APPLICATION FOR CERTIFICATION  
FOR THE PALMDALE HYBRID  
POWER PROJECT

**ERRATA TO EXHIBIT 402:  
ADDITIONAL TESTIMONY SUBMITTED ON FEBRUARY 4, 2011  
BY CENTER FOR BIOLOGICAL DIVERSITY**

**Testimony of Gregory Tholen  
Autumn Wind Associates, Inc.**

**Re: Road Paving Offsets**

**Figure 1:**  
Fraction of PM<sub>2.5</sub> (fine) and PM<sub>2.5-10</sub> (coarse) in PM<sub>10</sub> emissions contained in entrained road dust from unpaved roads (left) and combustion exhaust from gas-fired stationary internal combustion engines (right)

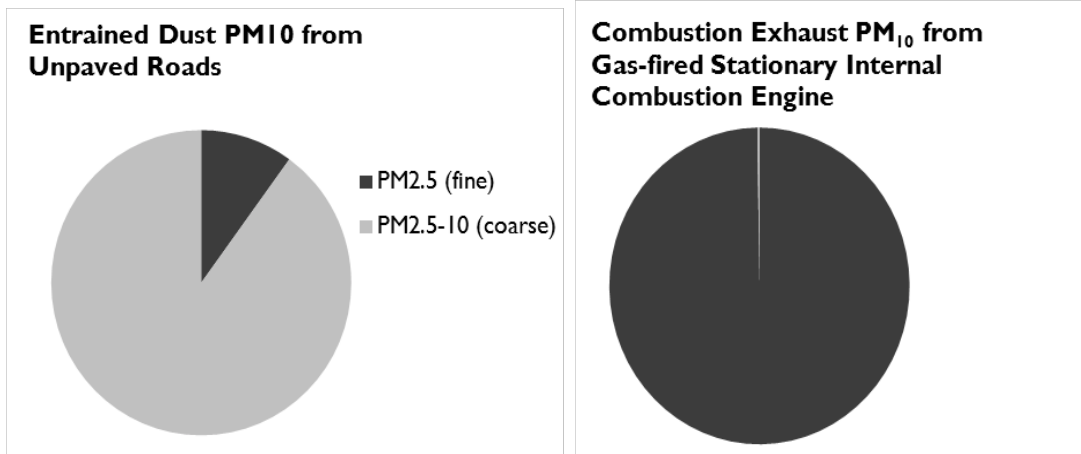
Numerous studies have shown that fugitive dust PM10 consists of about 90 percent coarse particulate matter, *i.e.* PM2.5-10, and only about 10 percent PM2.5 or fine particulate matter.<sup>2</sup> In contrast, combustion emissions from fossil fuel-fired sources are almost entirely composed of very small particulates. Figure 1 illustrates the fraction of PM2.5 contained in the PM10 emissions from entrained road dust from unpaved roads and combustion emissions from a gas-fired stationary internal combustion engine.

**Figure 2:**  
**Comparison of PM<sub>2.5</sub> and PM<sub>2.5-10</sub> size fractions in PM<sub>10</sub> combustion emissions increase from a natural gas-fired power plant and PM<sub>10</sub> entrained road dust emissions reduction from PERCs**

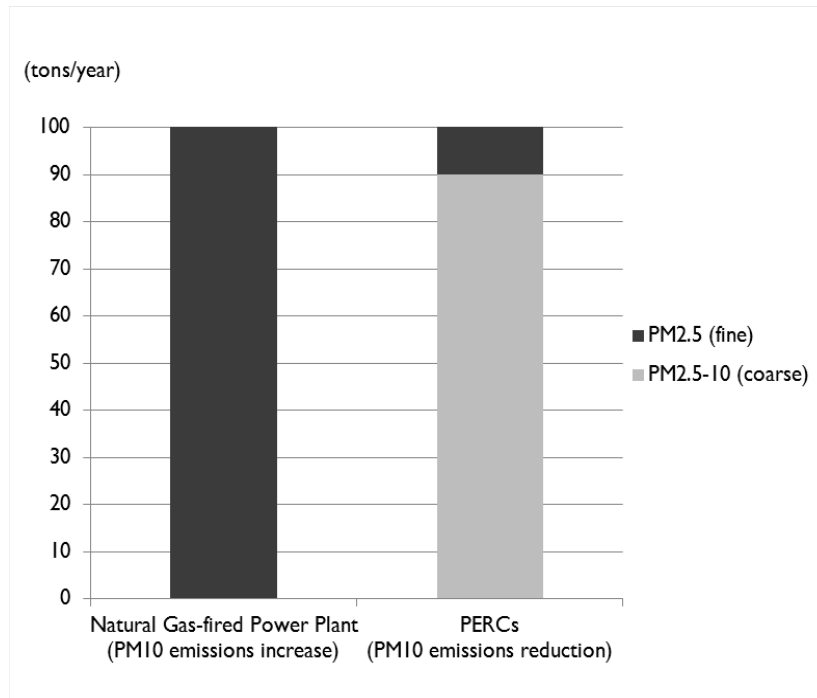
Figure 2 below illustrates how offsetting PM<sub>10</sub> emissions from a natural gas-fired power plant with entrained road dust-based PERCs would increase PM<sub>2.5</sub> emissions.

Combustion emissions from the natural gas-fired power plant turbines are fine particulate matter, *i.e.* equal to or smaller than 2.5 micrometers. The PM<sub>10</sub> emissions reductions from paving an unpaved road consist of coarser particles with a diameter between 2.5 and 10 micrometers. Thus, when offsetting, for example, 100 tons/year of PM<sub>10</sub> combustion emissions with PERCs, 99.8 tons/year of PM<sub>2.5</sub> emissions would be offset with 9.98 tons/year of entrained road dust PM<sub>2.5</sub> and 89.82 tons/year of PM<sub>2.5-10</sub>. Thus, the example offset scheme would result in a net increase of 89.8 ton/yr of PM<sub>2.5</sub>, the fraction of particulate matter that poses the most significant health risk.

These potentially significant impacts on air quality must be evaluated and, if found significant, mitigated as required by CEQA.
